Steubing Estate POADP

POADP # 496

SUPPLEMENT TO THE STEUBING ESTATE P.O.A.D.P. #539
SHOWING
THE PROPOSED CIRCULATION SYSTEM
FOR
STEUBING RANCH SUBDIVISION

On behalf of the owner/developer of STEUBING RANCH SUBDIVISION UNIT 3, we respectfully request a variance to Sections 35-2075 (e) and 35-2076 of the Unified Development Code (UDC). The Planning Department cited this subdivision as not complying with same. Both of these sections deal with Preliminary Overall Development Plans (POADPs). Section 35-2075 (e) relates – in part - to “proposed circulation system of collector, arterial, and local type B (clearly identified), and their relationship to any adjacent major thoroughfares”. Section 35-2076 relates to “terms of validity”.

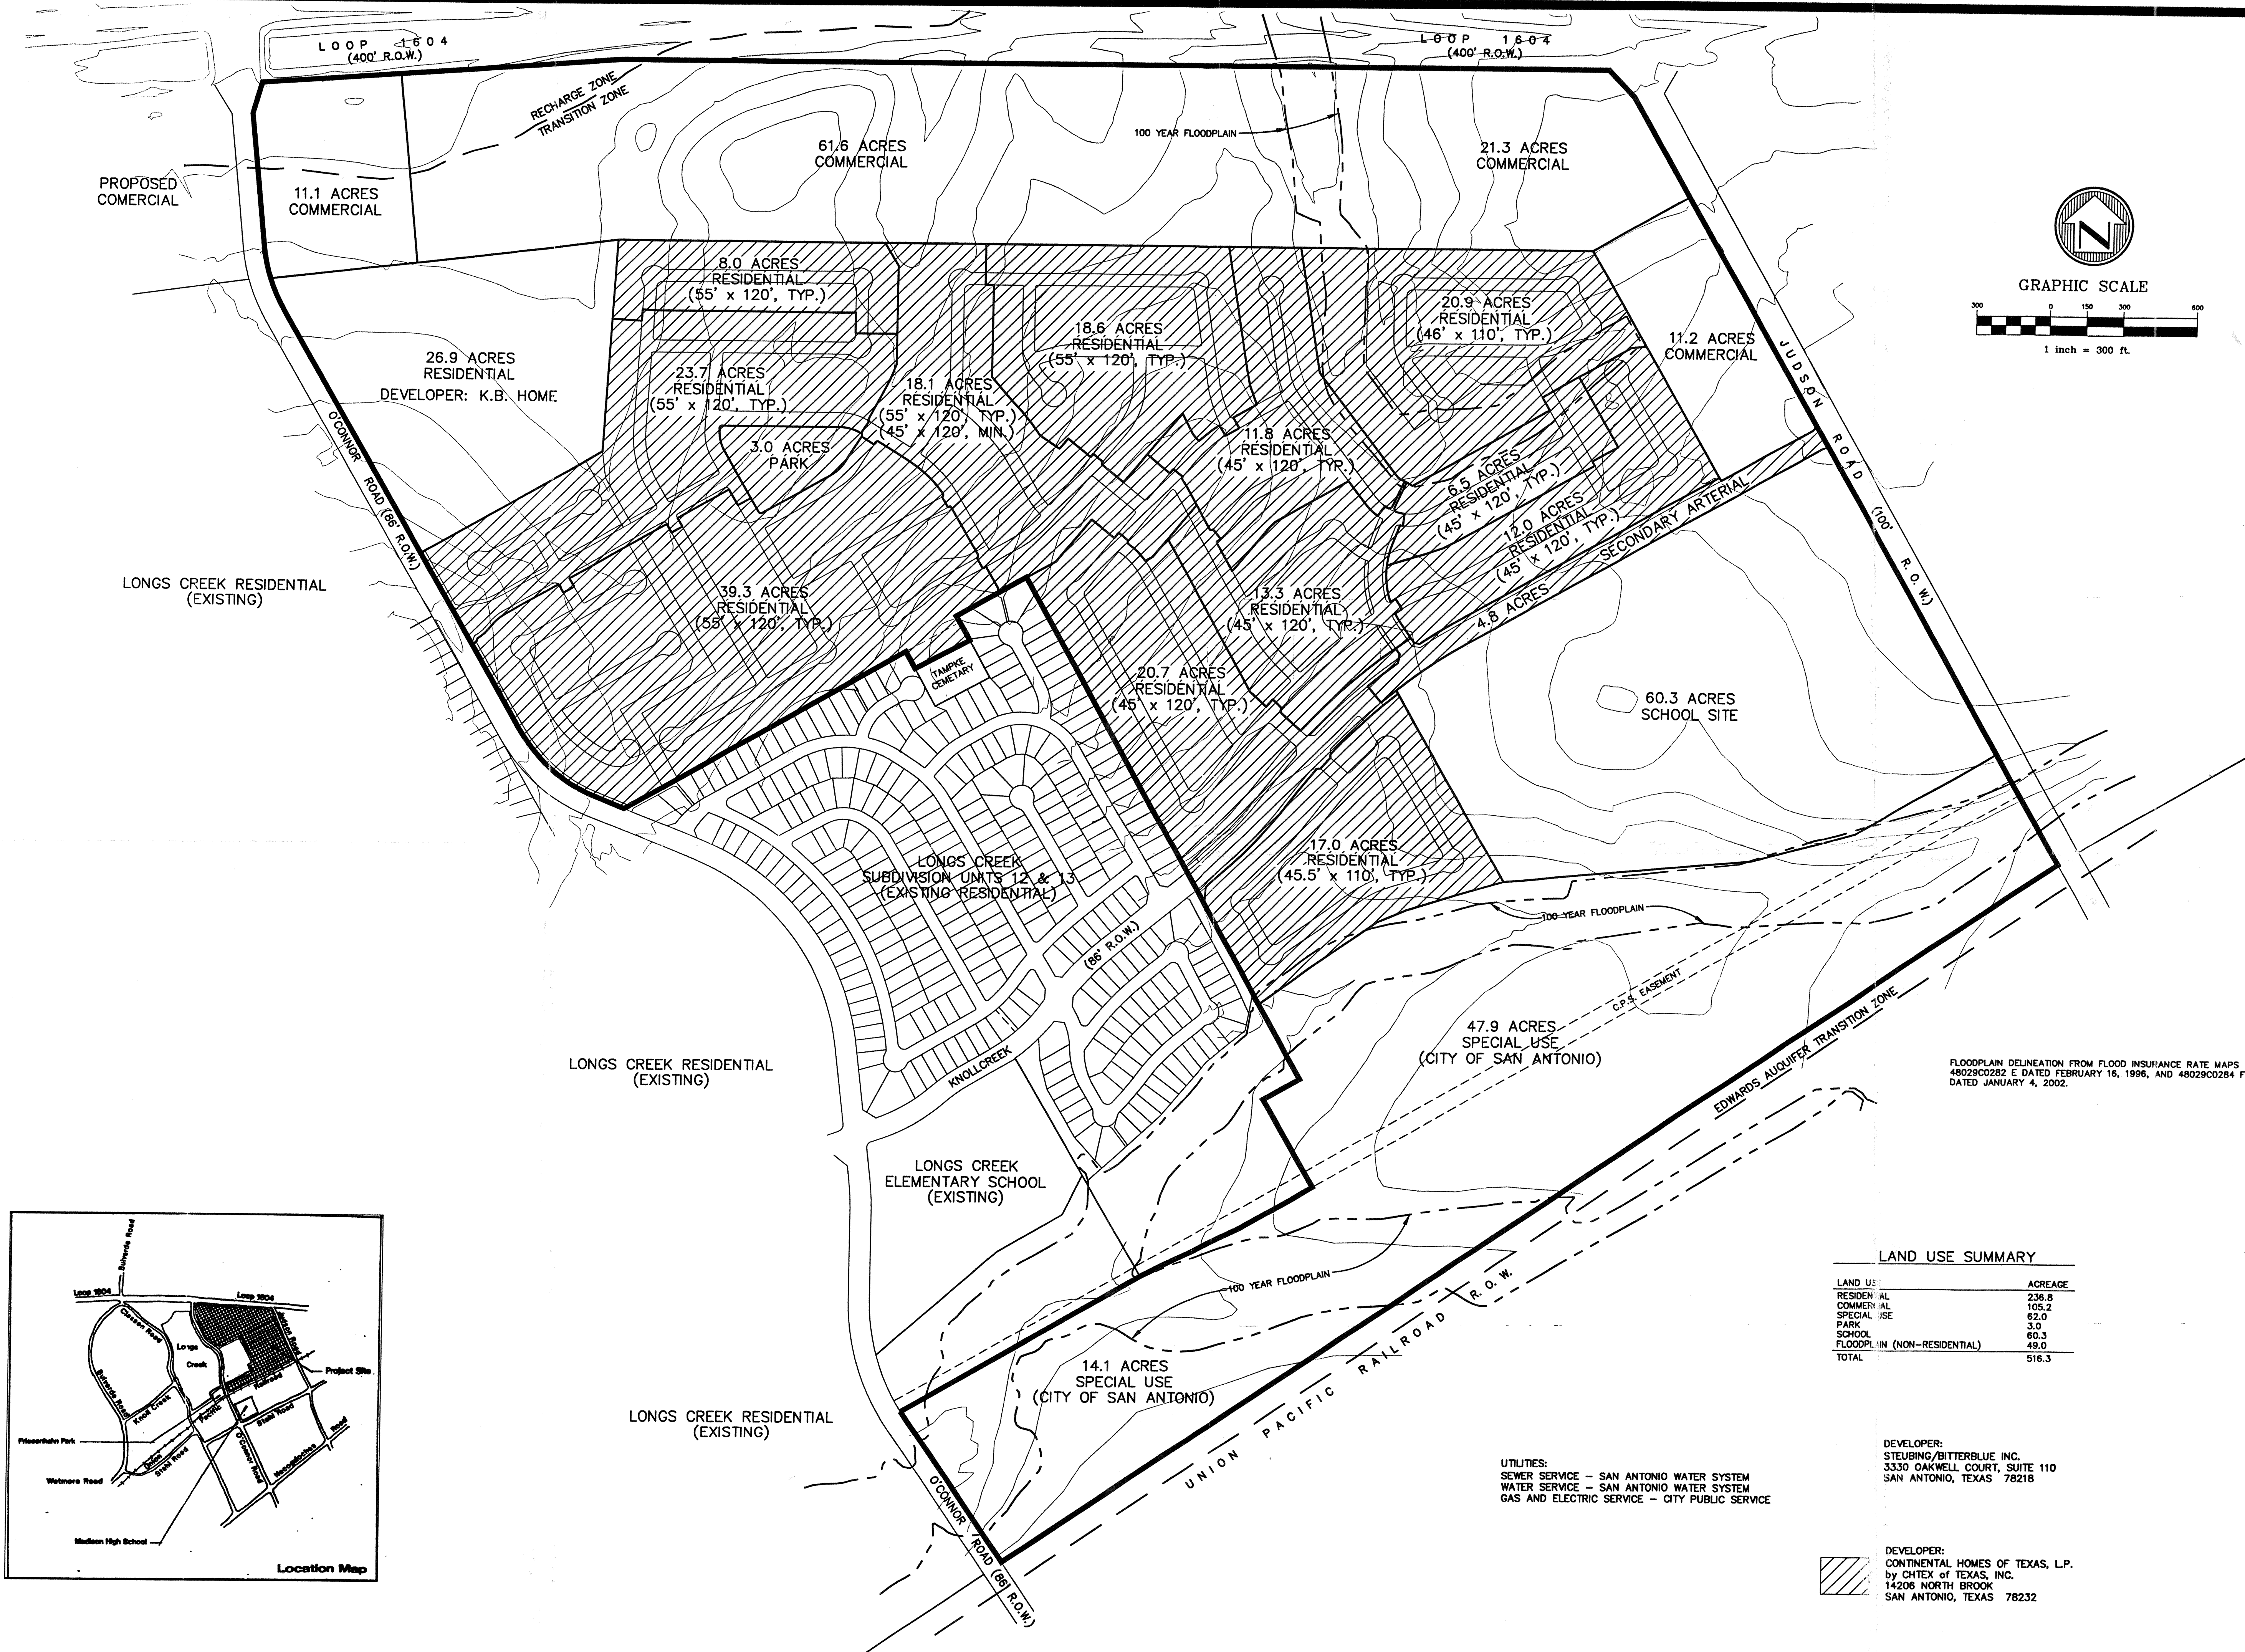
THIS COPY WAS PROVIDED BY
MR. TIM PRINCE IN RESPONSE TO
ONE COMMENT (2-11-03) (NO CHANGES)

REVISIONS:
04/05/03 REVISE LOCAL "B"
JOB NO. 052247038
FILE: ~
DATE: 12/30/02
DESIGN: B.H.
DRAWN: B.H.
CHECKED:
SHEET 1 OF 1
